MILLENNIUM TOWER

PERIMETER PILE UPGRADE

DBI Report: 301 Mission Voluntary Foundation Retrofit

Response to Supplement No. 188, the response dated July 25, 2019, to my press release

Casing Install Procedure Pilot Program

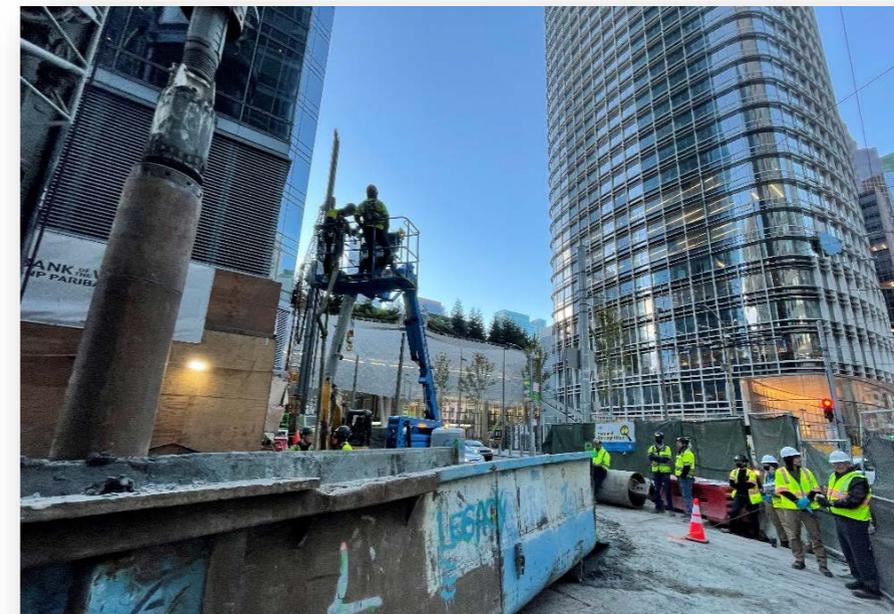
And the most embarrassing thing was Ben Turner's slide that said: "negligible settlement = success". See the attached three figures from the monitoring report that was released yesterday, which show that the rates of settlement and tilting after the installation of three casings have returned to about what they were before the pause in late August. It is great that Ben is now monitoring the water level in the casing and the depth of the plug more closely, but why was that not done from the getgo? And is this success?

Figure A1 – Settlements

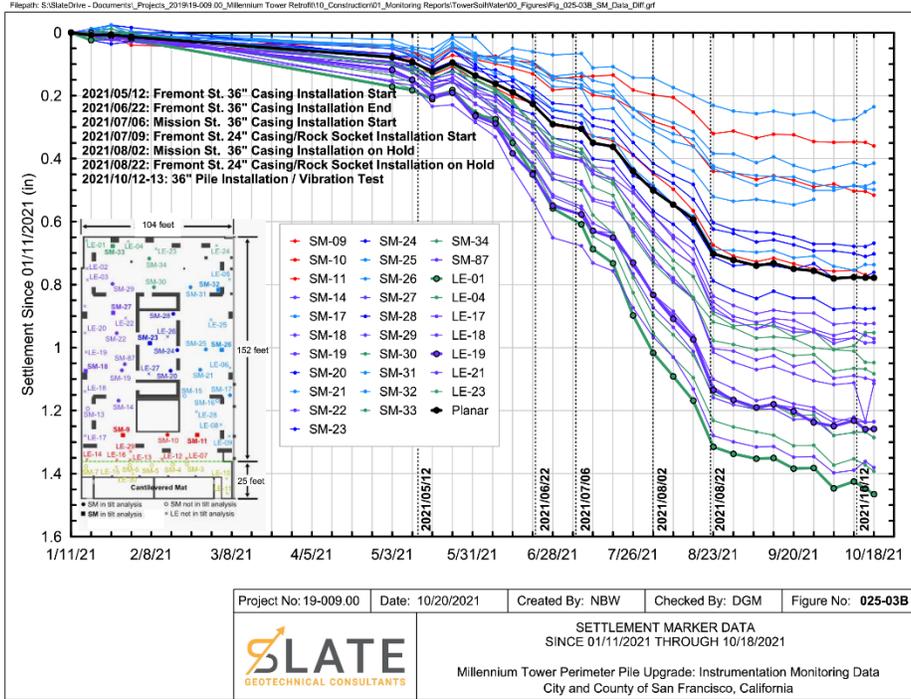
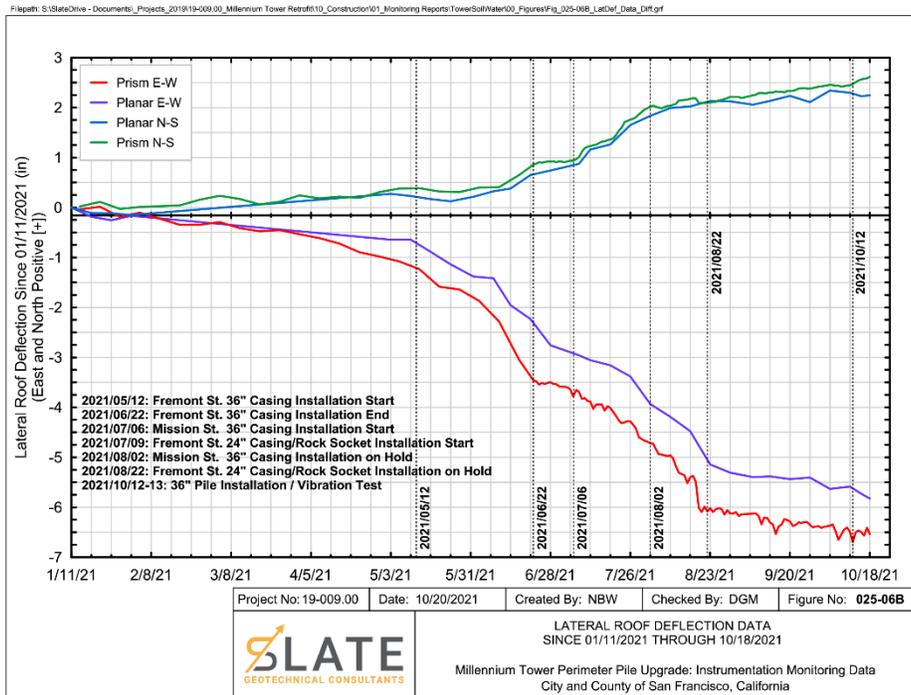
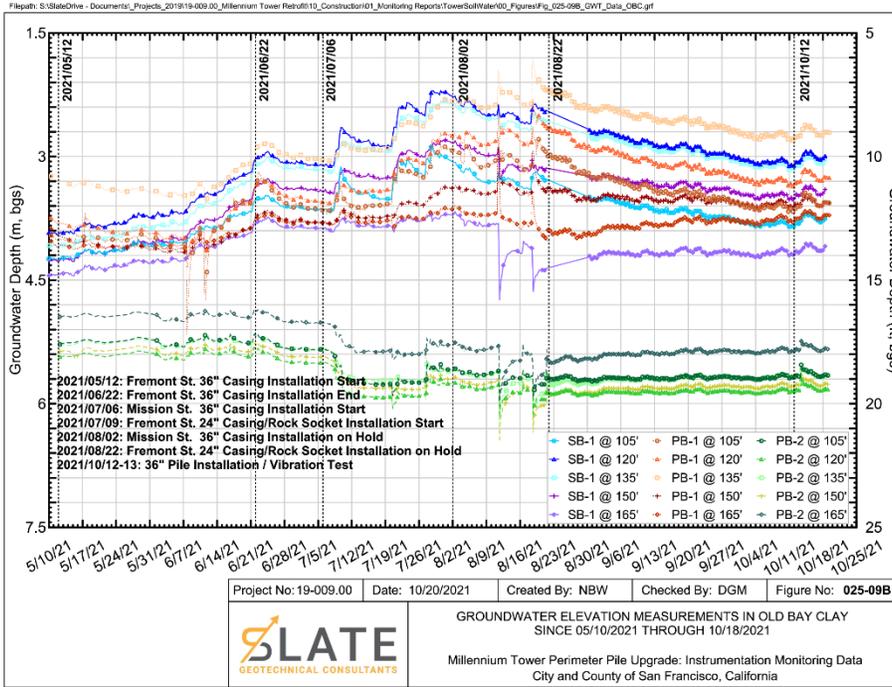
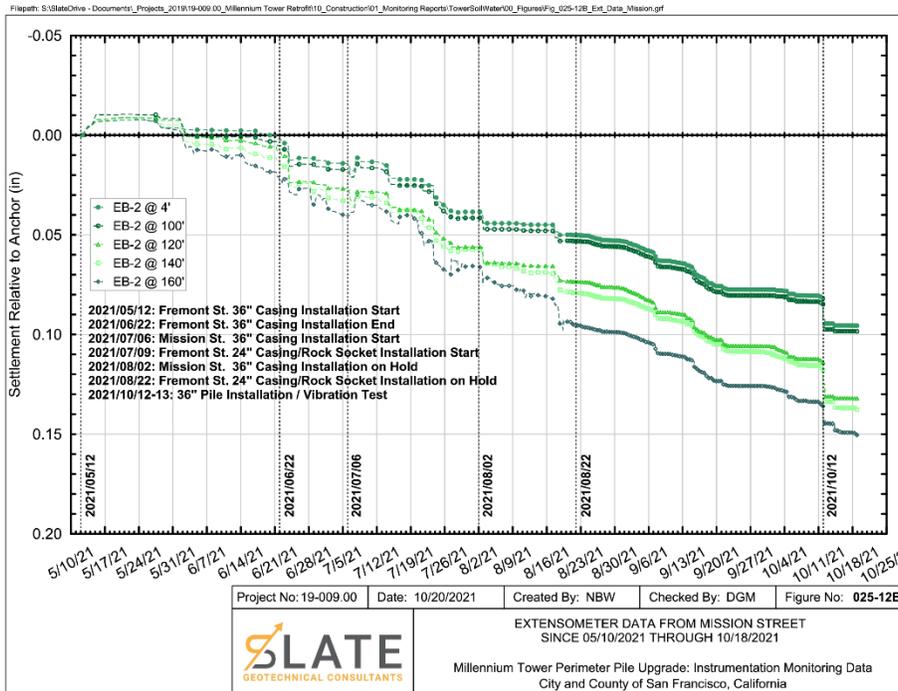
However, Monitoring Report No. 025, which includes data through October 19, tells a different story, indicating once again that Mr. Hamburger appears to be over-optimistic, a Pollyanna who always puts

the best possible interpretation on events, rather than emphasizing the uncertainties and the unknowns. The data presented in Figures A1 and A2 indicates that both the settlement of the NW corner of the building and the lateral roof deflection to the west (over Fremont Street) kicked up in the week following the installation of the test casing. Not by a lot – these are still pretty small numbers – but enough to be significant. My reading of the data is that the NW corner settled about 0.05 inch and the westwards lateral roof deflection was about 0.25 inch, that is $\frac{1}{4}$ inch. The ratio of westward lateral roof deflection to settlement was 5, consistent with what has been seen in the production pile installation. The lateral roof deflection, an indication of the “tilt”, is of course greater during the PPU installation than it was in previous ongoing settlement and tilt because the enhanced settlement is only occurring on the north and west sides of the building, so that the differential settlement is greater. Mr. Hamburger may not understand this, because when he was predicting that the settlement would not exceed $\frac{1}{8}$ inch, he said that the lateral roof deflection would not exceed $\frac{1}{4}$ inch. He was lucky that the settlement was well under $\frac{1}{8}$ inch (0.125 inches), otherwise the “tilt” would have blown through his maximum of $\frac{1}{4}$ inch instead of just hitting it.

But it is Figure A3 that provides some insight into why at least some settlement is delayed. This figure indicates the excess pore pressures in the Old Bay Clay (OBC) that is found from depths of approximately 100 feet to 200 feet. It is this layer that is the primary cause of the settlement of the building because the net weight of the building is transferred by the forest of concrete piles under the core and the perimeter mat to the sand layers above the OBC, and this applies enough pressure to the OBC that it has apparently been pushed back onto its “virgin consolidation curve”. That does not cause immediate settlement because of the low hydraulic conductivity of the OBC, but settlement occurs over time as the excess pore pressures slowly dissipate. The vertical axes on Figure A3 are labelled “groundwater depth, bgs”, which is an odd, but not incorrect, way of representing the total pore pressure. The numbers that are plotted are the depth below the ground surface (bgs) that water would theoretically rise to in an open standpipe with its bottom at the depth of the measuring device. The excess pore pressure (in feet of water) is then the difference between that elevation and the present elevation of the groundwater. I am not sure what that is at the relevant locations, but alternately, if the values in the sand layers above the OBC are hydrostatic, the difference between those values and the values reported for the OBC, assuming of course that the measurements are correct, are an indication of the excess pore pressures in the OBC. The “ground water depth” in the marine and Colma sands appears to be in the order of 20-21 feet bgs while the bulk of the data in the OBC now lies between 9 and 14 feet and was 13 to 15 feet back in May before the PPU installation commenced. Thus, the excess pore pressures in the OBC increased in response to the PPU installation and then started to drop off once the installation was paused. This means that the PPU installation applied at least some load to the OBC and that some settlement occurred as the corresponding excess pore pressures were dissipated.

I continue to believe that mechanism 4 is most unlikely and that mechanism 3 is possible, but not confirmed. Mechanism 1 has yet to be explored further by a test installation of a 24-inch pile. But the data in Figure A4 suggests that mechanism 2 might still be operative because, in addition to the delayed increase in the rate of settlement, there was some immediate settlement on October 12th and 13th.

Figure 1 – Vs profile from Supplement No. 34

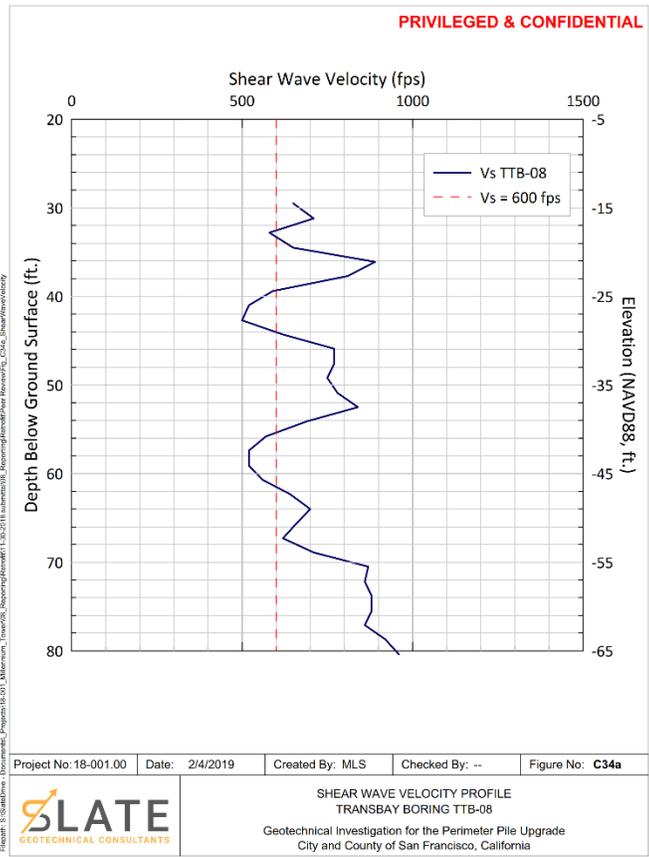
There are multiple issues involved in this point and the following two points. The issue of whether the Site Class should be D or E might be less important than whether the acceleration histories used as the input to the structural analyses are appropriate and whether they are applied correctly to the structural model, but it is still significant because of the language of the building code. The issue of site classification is relatively straightforward and it is hard to understand why Hamburger is so evasive in addressing this and why the EDRT signed off on the rambling response to Comment 34.

Hamburger's response to Comment 34 refers to shear wave velocities measured in Boring TTB-08 drilled for the Transbay Terminal, which was included in Supplemental Report No. 34. I am including that below, following the response to Comment No. 34, as Figure 1.

As indicated by the comment, there are some zones within the subsurface profile that have shear wave velocities (V_s) less than 600 fps, notably within the Recent Bay sediments (i.e., Young Bay Mud and Marine Sands). This is illustrated by the attached figure of shear wave velocity measurement obtained using suspension logging in Boring TTB-08, drilled on Fremont Street within about 25 feet of the Tower. We note that there are two zones, each approximately 5-ft-thick, for which the shear wave velocities (V_s) fall below 600 fps. We note however, that even with these thin low-velocity zones, the V_{s100} for the profile exceeds 600 fps and falls within the V_{s100} range (600 to 1200 fps) for Site Class D. In addition, examination of the measured undrained shear strengths (S_u) for the soils within the profile (see attached figure) indicates that none of the laboratory- or field-measured undrained shear strengths within the profile below the bottom of the mat are less than $S_u = 500$ psf and the average S_{u100} is ≈ 1000 psf. Given that the calculated V_{s100} for the profile exceeds 600 fps, none of the measured undrained shear strengths are less than 500 psf (a requirement of ASCE 7-10 Section 20.3.2 for designating a site as Soft Clay Site Class E), the average S_{u100} is ≈ 1000 psf, and the average SPT penetration resistance for the cohesionless soils, N_{ch100} is ≈ 40 , we are of the opinion that Site Class D is the appropriate Site Class designation for the soil profile. See Supplement No. 34 for visual comparisons.

Figure 2 – Vs profile from Egan/S&W/Slate Geotechnical Report

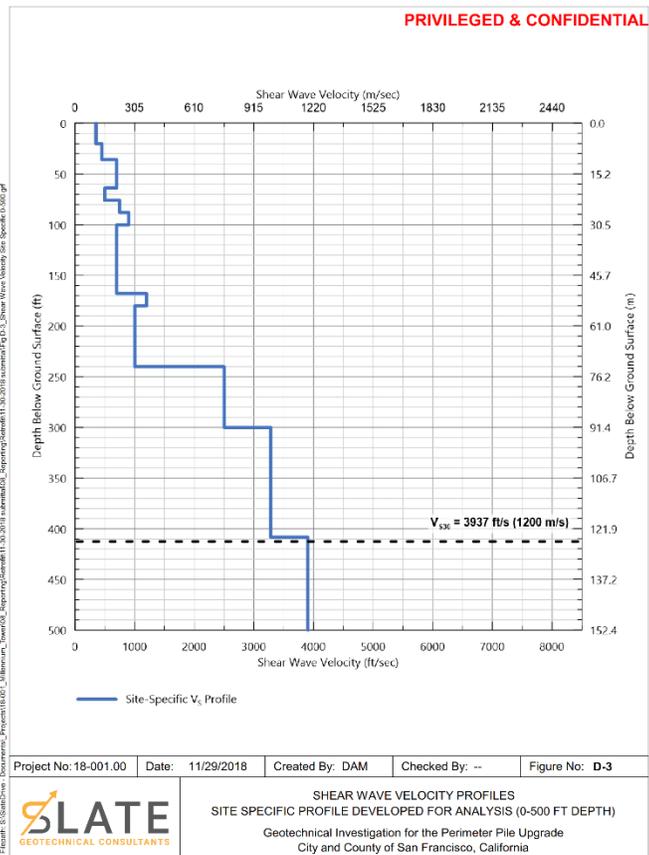
But in 2018, in the Egan/S&W/Slate geotechnical report, it is indicated that the shear wave velocity profile that they used for analysis of the site response was as shown below in Figure 2 - note the softer top which makes it Site Class E – I know that the input motions for the structural analyses were defined at the base of the perimeter mat, but the building code says that site classes are "based on the upper 100 feet (30 m) of the site profile."

The comment seems to be aimed at understanding why Site Class D has been selected instead of Site Class E. Section 20.3.2 of ASCE 7-10 and 7-16, Soft Clay Site Class E, states "Where a site does not qualify under the criteria for Site Class F and there is a total thickness of soft clay greater than 10 ft (3 m) where a soft clay layer is defined by $S_u < 500$ psf ($S_u < 25$ kPa), $w >= 40\%$, and $PI > 20\%$, it shall be classified as Site Class E."

Figure 3 – My Computed Free-Field Ground Surface Response Spectra

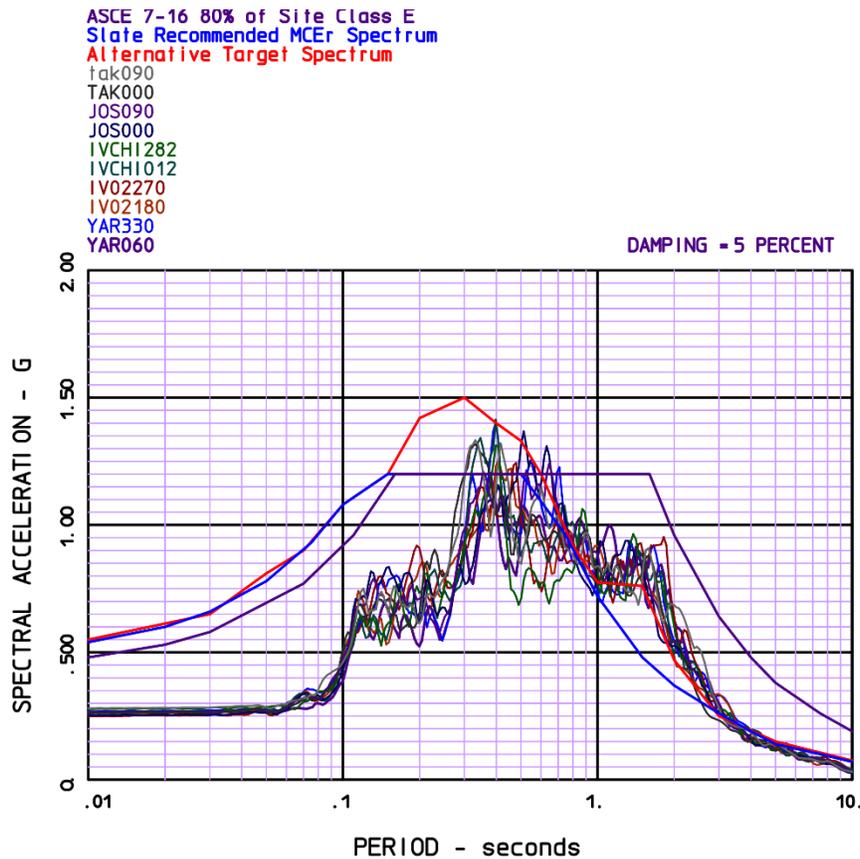
The results of my own site response analyses, using input motions matched to the building code Site Class B spectrum for this site and applied at the top of the Franciscan formation bedrock, and using the Egan/S&W/Slate shear wave velocity profile, are summarized in the next two figures showing the computed ground surface response spectra. Figure 3 shows the results for the “free-field” profile, and Figure 4 shows the results for a profile that stops 25 feet below the ground surface, or at the base of the perimeter mat. The effect of adjacent buildings is not taken into account.

It may be seen that, except at very short periods, there is not that much difference between the computed spectra in Figures 3 and 4, confirming that the Old Bay Clay layer has more impact on the site response than the top 25 feet of the profile.

Figure 4 – My Computed Ground Surface Response Spectra for 25 feet BGS

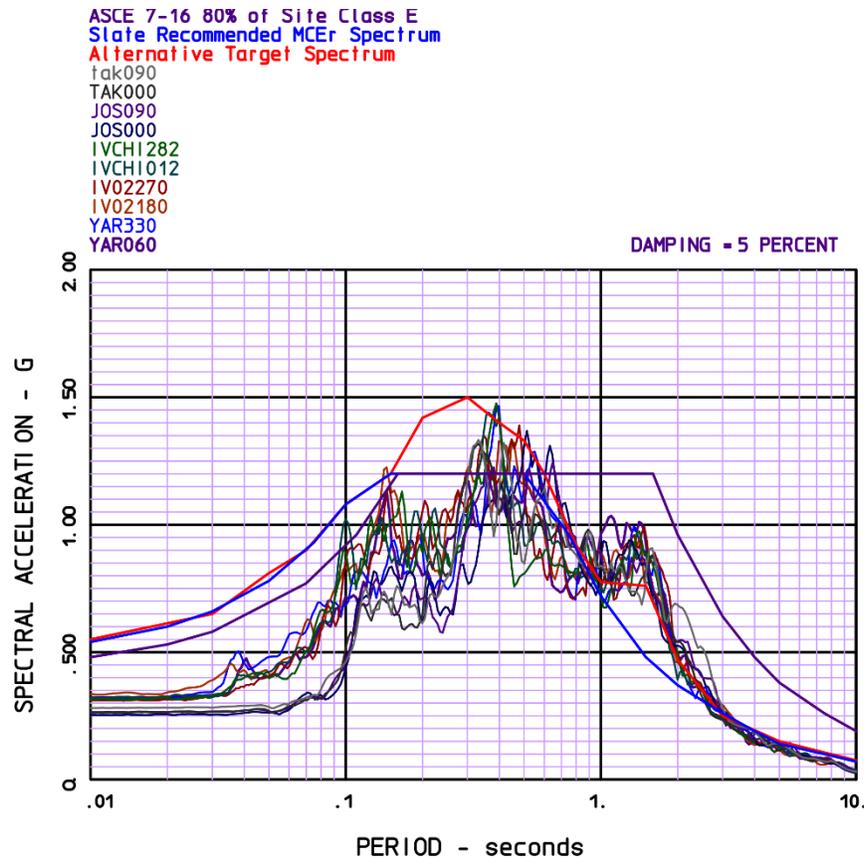
For comparison, three other spectra are shown in these figures. Shown by a blue line is the response spectra recommended by Slate and based on their own site response analyses. These analyses were “equivalent linear” analyses that used entirely inappropriate modulus reduction curves for some layers and had generally quite low longer period responses so that the recommended spectrum was

controlled by 80 percent of the then building code spectrum for Site Class D. To their credit, SGH recognized that this spectrum was inadequate and so they adopted the spectrum shown as a red line, labeled Alternative Target Spectrum on the plot, which had been developed by ENGEO for the competing LERA proposed solution. It may be seen that although the ENGEO analyses appear to have used slightly stiffer “backbone curves” for their nonlinear site response analyses than I used in mine, the results are not dissimilar. Although I am using the same shear wave velocity profile, my analyses are pretty much an independent third-party analysis and I would conclude that while the ENGEO results are a little less conservative than mine, they are in the right ballpark. As I understand it, John Egan then fitted his choice of acceleration histories to the ENGEO spectrum and those acceleration histories were used to drive the PERFORM 3D nonlinear structural model at the base of the perimeter mat.

is quite striking and would remain so even if the 80 percent were reduced to 70 percent as allowed by the current building code for buildings with an embedded foundation. This occurs partly because the site response analyses assume vertically propagating shear waves and they may be unconservative at longer periods, since the longer period motions in earthquakes are principally generated by surface waves. Further study would normally be required to justify the use of spectral accelerations at 5 seconds any lower than 70 percent of the standard building code spectrum.

Figure 5 – Slate’s Prediction of Future Settlements

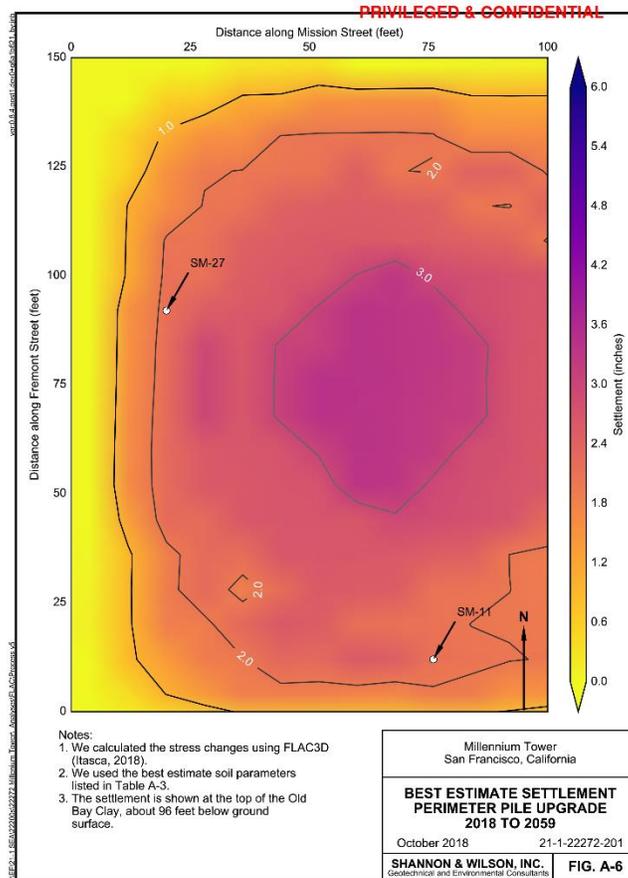
This is an amazing response centered on the definition of immediate. I understand that, in theory, relieving the load on the Old Bay Clay might lead to a small amount of rebound but this requires sucking in water which would likely take more than one or two years. And Slate’s prediction of future settlements shows no rebound at all, as can be seen in Figure 5.

Figure 7 – From SGH Supplemental Report dated July 26, 2017

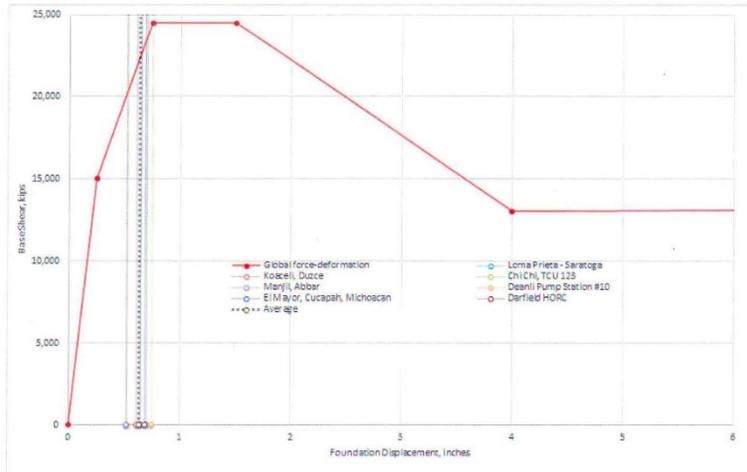
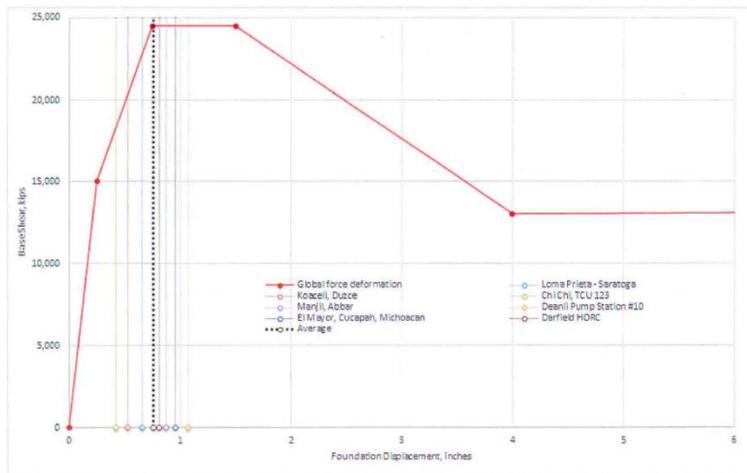
The report’s description of these figures is: “Figure 37 and Figure 38 respectively present the peak lateral displacement demands on the pile cap in the east-west and north-south directions, overlain on the global pile nonlinear force-displacement behavior previously shown in Figure 22. Predicted pile lateral displacement is typically less than 1 inch and does not approach the displacement at which foundation strength degradation initiates.” The development of the global force-displacement relationship for lateral loading is described in the report but it is less than clear why it ends up having a significant drop from the peak capacity and it is not clear at all how this relationship reverses when the direction of shaking reverses. And there were necessarily a number of approximations made in constructing this relationship. So, the answers obtained in each direction are just one possible answer and are not necessarily the correct answer. But, if these force-displacement relationships are correct, it is curious that the peak demand falls just short of the capacity. The implication of this is that, given even a small increase in the earthquake loading, the Tower might end up in either Fremont or Mission Streets. I really don’t think that will happen because the passive

The two previous figures in this report, which are too detailed to include in this commentary, show a similar result relative to the axial capacities of the piles. In both compression and tension, many of the demand-to-capacity ratios are close to 100 percent. That might be explained by the values that are shown being the maximum of seven runs using two horizontal components of motion, but why are so many of them close to 100 percent but not equal to it, and why are there sometimes adjacent values that are much lower? There is nothing wrong with an individual pile reaching a demand to capacity ratio of 100 percent, because that just means that there will be load re-distribution to the adjacent piles, but that does not appear to be what happened. And what would happen if the full vertical component of motion was included in the analyses?
